REVIEW COMMENTS

WILLOUGHBY CORNER (SKETCH)

PROJECT TECHNICAL MEMORANDUM

To: Jana Easley Proj. # 19-100 ~ Willoughby
From: Pat Sorenson, City Interim Plan Review Engineer
Project: **Willoughby Corner Sketch Plan**
Date: 06.11.19

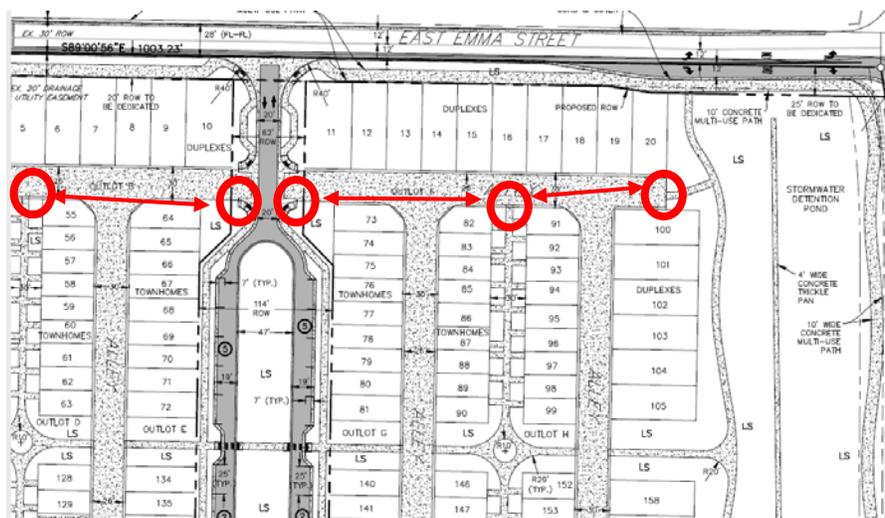
22. The Emma St round-about has been moved south to be fully within the city limits. If the north half of Emma St is within (or anticipated to be within) the city limits as this project moves through the process, that round-about will need to be redesigned. You may be able to construct the south half of the east-bound round-about and leave the north side/west bound in its current configuration (straight). Continue to work through this with Public Works/Engineering for the best solution.

CONCEPT PLAN FOR 120TH STREET

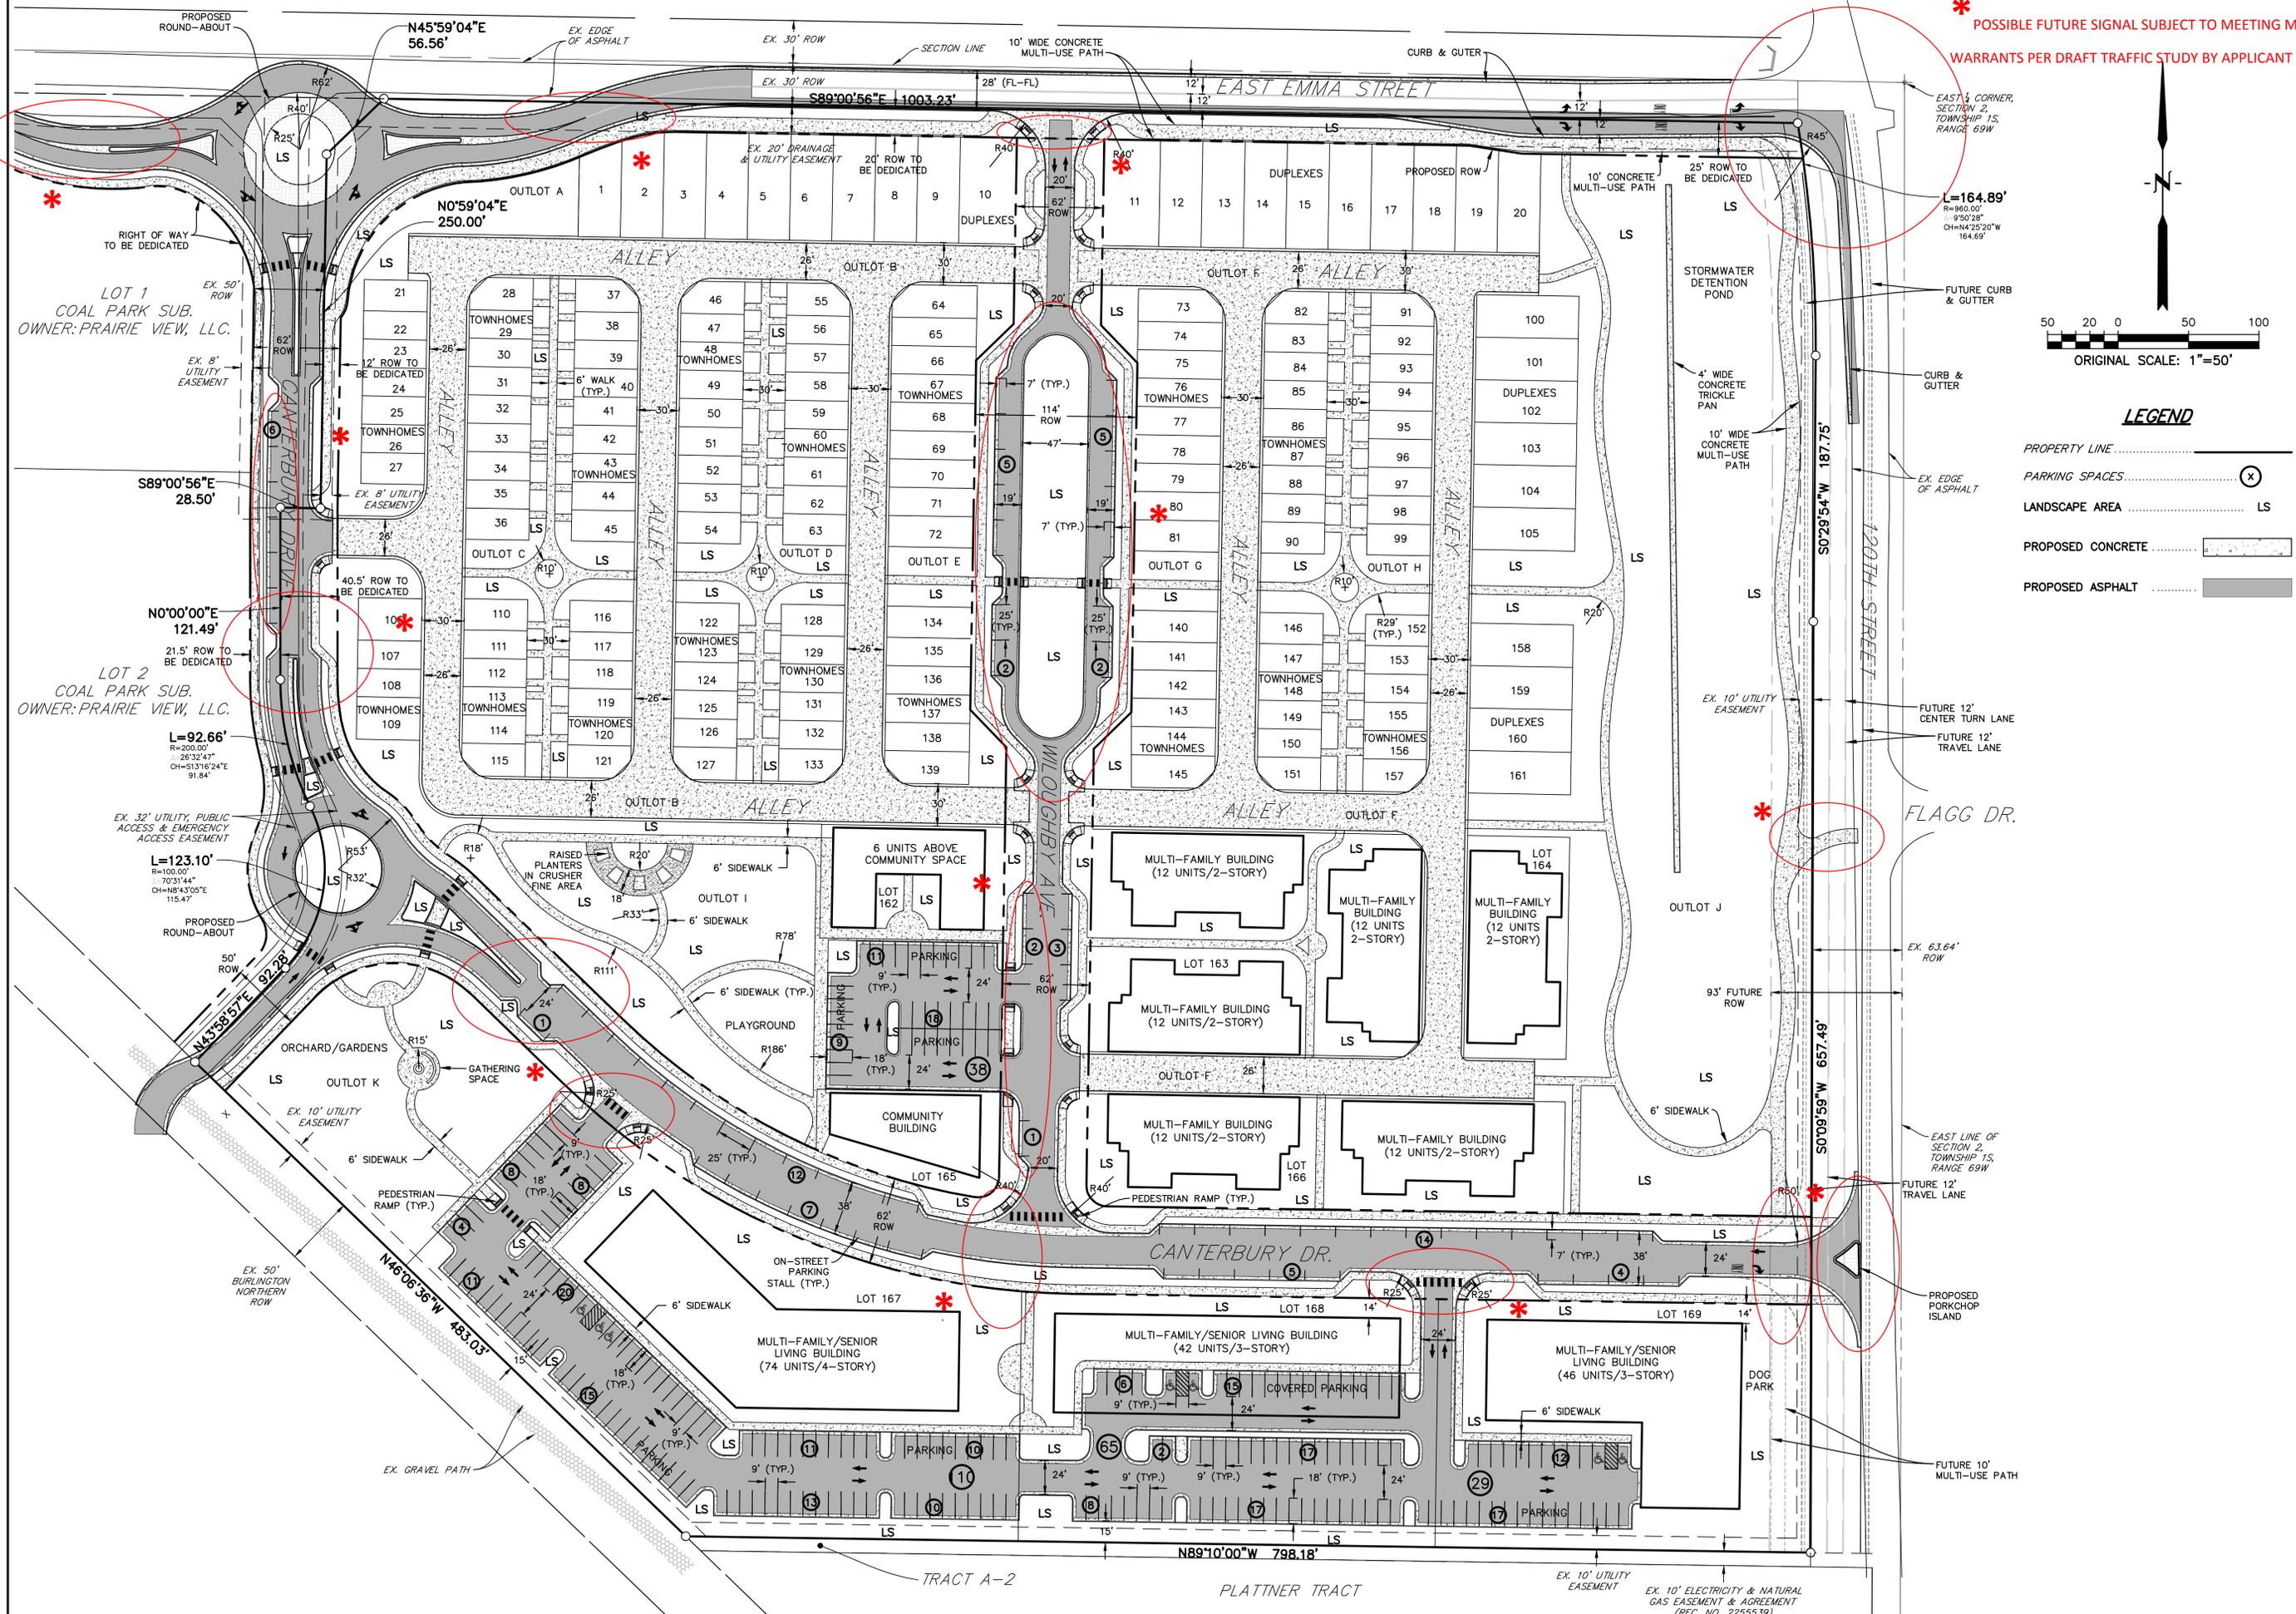
- The 120th Street alignment needs to more clearly consider the October 2014 SOUTH BOULDER ROAD & 120TH MASTER PLAN REPORT.(2014 Master Plan) Section information was previously provided by the applicant in a preapp. meeting, but that

- information doesn't seem to be consistent with the 2014 Master Plan nor the applicant's submitted Draft Traffic Impact Study. A concept exhibit attached to this memo depicts an overlay of the 2014 Master Plan alignment onto part of Willoughby Corner. The applicant's engineer will need to submit a more detailed conceptual layout to staff providing a much higher level of assurance toward a working layout for this site-specific alignment which may need to be provided by their specialized transportation engineer.

SHEET TITLE:
 SITE PLAN

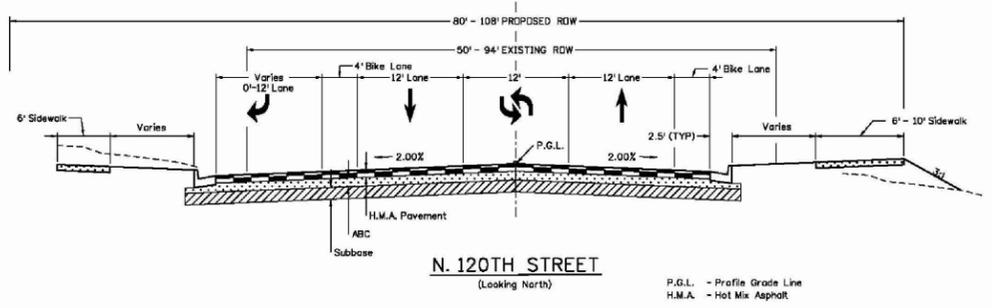
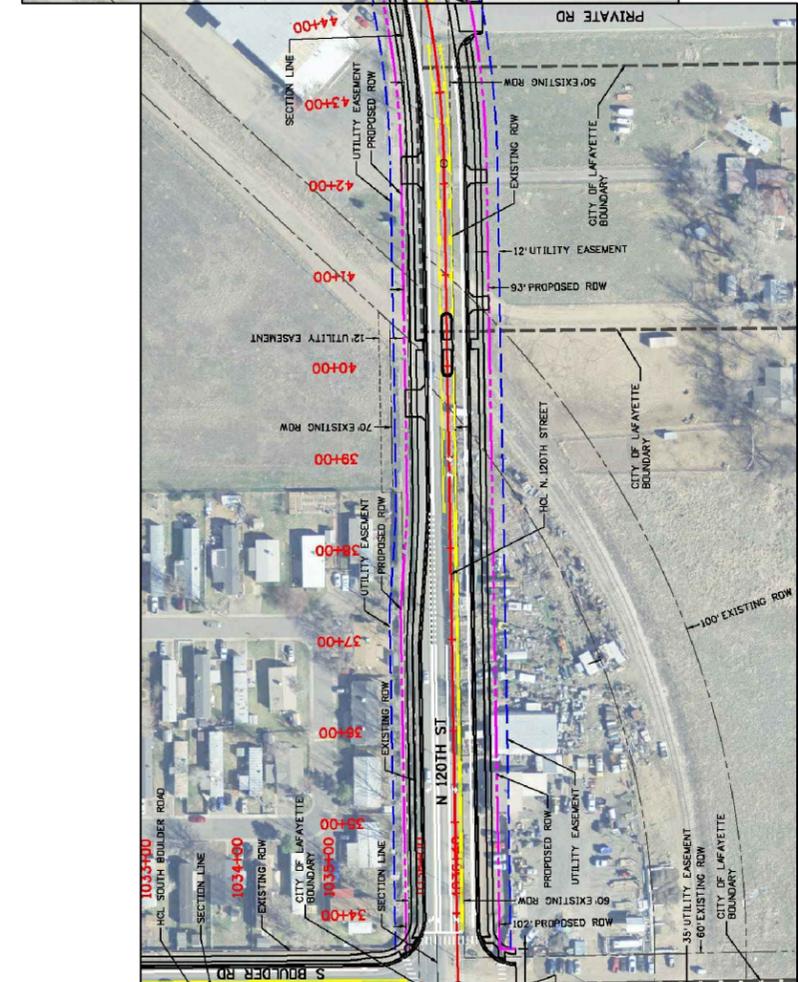
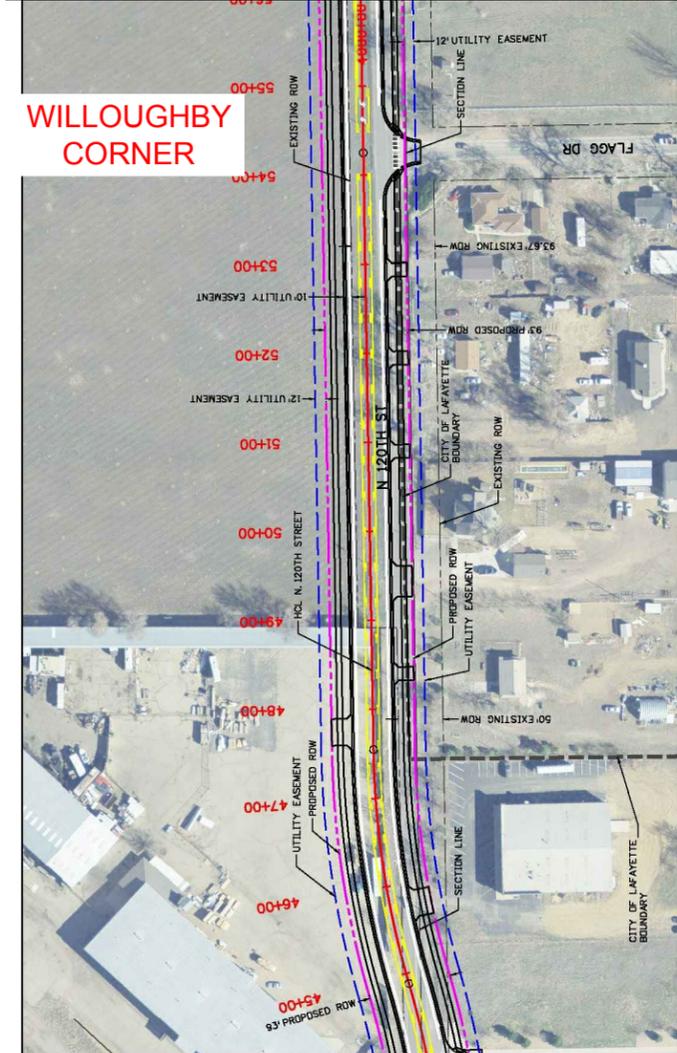
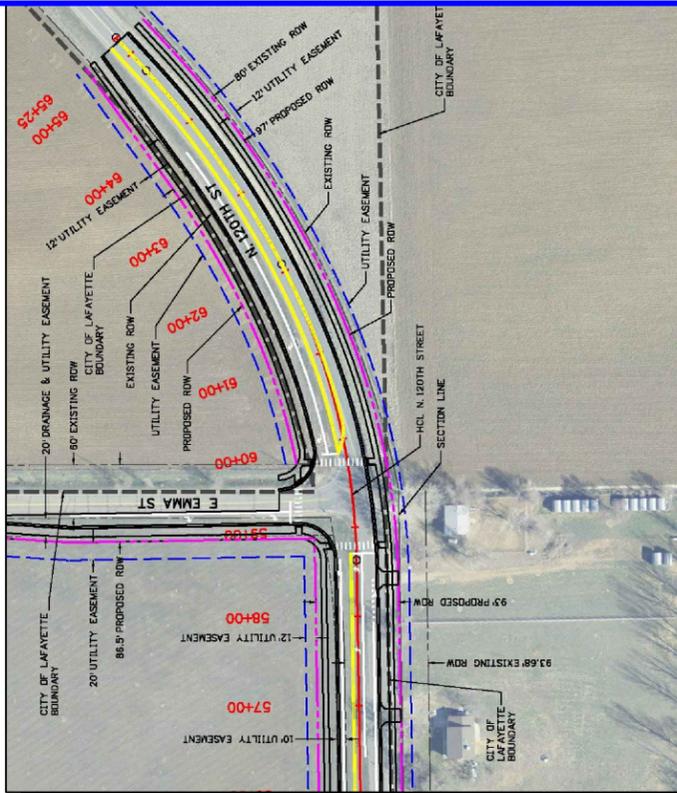
- Willoughby Avenue design has numerous parking and width issues. *The southerly 3 parking spaces on the west side should be eliminated due to their proximity to a

- somewhat busy intersection and high activity areas. Pursuant to Table 1400-2, Street Design Criteria, City Standards and Specifications, the travel lane widths need to be 12', however, in one-way situations, i.e., at the center court area, these need to be 15', i.e., the minimum width for emergency vehicles plus the 7' parking spaces shown. All crosswalks on this street need to be striped. All connecting side alleys need to be posted with stop signs. Also, this street needs to be posted with stop signs at Emma and Canterbury.

- *Canterbury Street design aligns well for a local/collector functioning street with the exception the triangular islands at the roundabouts that do not allow for adequate laneage transitions. *The pork chop at 120th will not restrict left turns out and possibly in for the extent needed. This right turn only intersection is not consistent with the traffic impact study that provides for $\frac{3}{4}$ movement. The applicant's engineer will need to submit a more detailed conceptual layout to staff providing a much higher of level of assurance toward a working layout for this site-specific location which may need to be provided from their specialized transportation engineer. This also applies to the roundabouts, including signage thereto. *The 6 westernmost parking spaces need to be eliminated for smooth through movement and avoidance of parked car pedestrian crossings. *The parking spaces situated just to the east of the triangular island at the south round-about need to be eliminated due to crowding. *The crosswalks at the northwest corner of Lot 167 (senior housing) entry need to be modified to be linear as pedestrian crossings aren't shown to the northeast. *A crosswalk needs to be added on Canterbury from the northeasterly corner of Lot 166 (senior housing) to the southeasterly corner of Lot 165 (community building). *The crosswalk at the southwesterly corner of Lot 155 (mf bldg.) needs to be modified to be linear. A crosswalk is needed at Canterbury and 120th. *The crosswalks at the northeast corner of Lot 168 and northwest corner of Lot 169 (senior housing) entry need to be modified to be linear as pedestrian crossings aren't designed to the northeast. The right turn at 120th will need to be posted with a Stop Sign. Last, pursuant to Table 1400-2, Street Design Criteria, City Standards and Specifications, the travel lane widths need to be 12.5'. (See further discussion below on 120th Street connection)

- *The Emma Street design appears to align well, inclusive of the round-about and lane age near 120th Street for a soon to be collector functioning street near a probable signal location at 120th with the exception that the triangular islands do not allow for adequate laneage transitions. (Public Works notes the roundabout is a significant change from the old town area street sections but such feature will be highly beneficial for traffic calming) The applicant's engineer will need to submit a more detailed conceptual layout to staff providing a much higher of level of assurance toward a working layout for this site-specific location which may need to be provided by their specialized transportation engineer. Again, pursuant to Table 1400-2, Street Design Criteria, City Standards and Specifications, the through travel lane widths need to be 12.5'. The turn lanes near 120th Street can be 12' wide but a 4' separation is needed between the proposed left turn lane and the west bound lane on Emma Street.

- *The 120th Street-Emma Street intersection needs to consider a future signal per the applicant's submitted Draft Traffic Impact Study. The applicant's engineer will need to submit a more detailed conceptual layout to staff providing a much higher level of assurance toward a working layout for this site-specific location which should be provided by their specialized transportation engineer for staff review.

- Regarding alleys, the westernmost connection and the entire outer loop will function as local streets and should be redesigned to comply with local street standards (possibly without parking on each side as a PUD exception); the northernmost ends needs to extend farther east and west to comply with emergency vehicle "hammerhead" criteria; and the southeasterly alley in the multifamily area should not loop as shown as this will promote through traffic which will likely be unsafe for the anticipated higher traffic volumes in this vicinity. An emergency vehicle and pedestrian/bicycle connection will be needed in place of this alley connection.
